ADDENDUM

MEETING OF THE PLANNING COMMITTEE WEDNESDAY 07th FEBRUARY 2024

PLANNING APPLICATION: 21/02289/OUT 1-12 Copthorne Brighton Road Burgh Heath Surrey KT20 6BQ

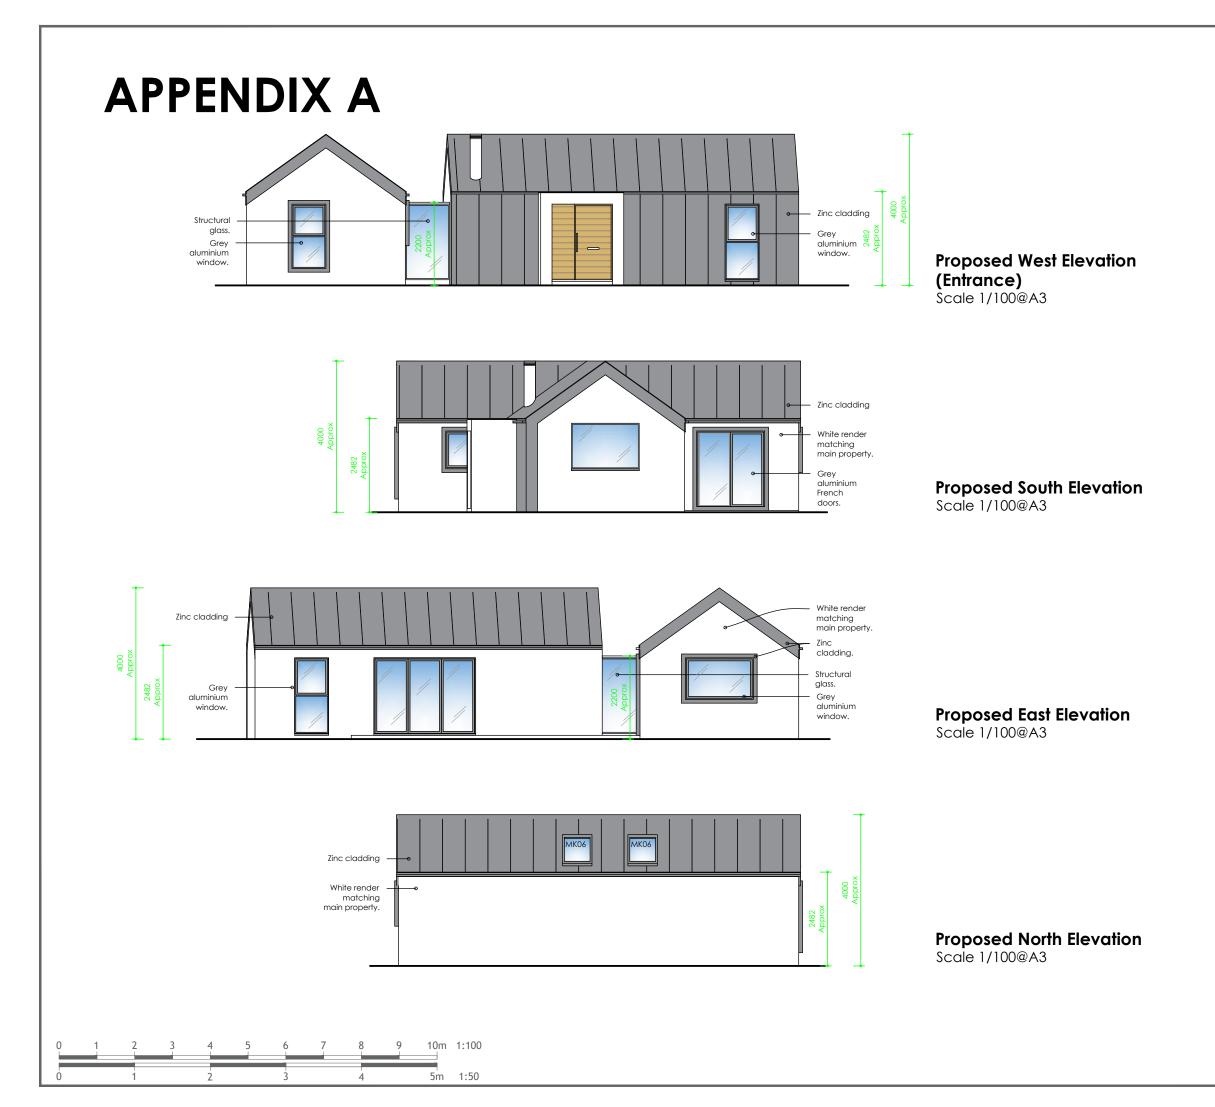
The following plans were not included within the agenda pack and are provided within the addendum for illustrative purposes at Appendix A:

Location Plan – Ref - 6119 OS 01p1 Proposed Elevations approved under 19/02208/CLP – Ref - 08
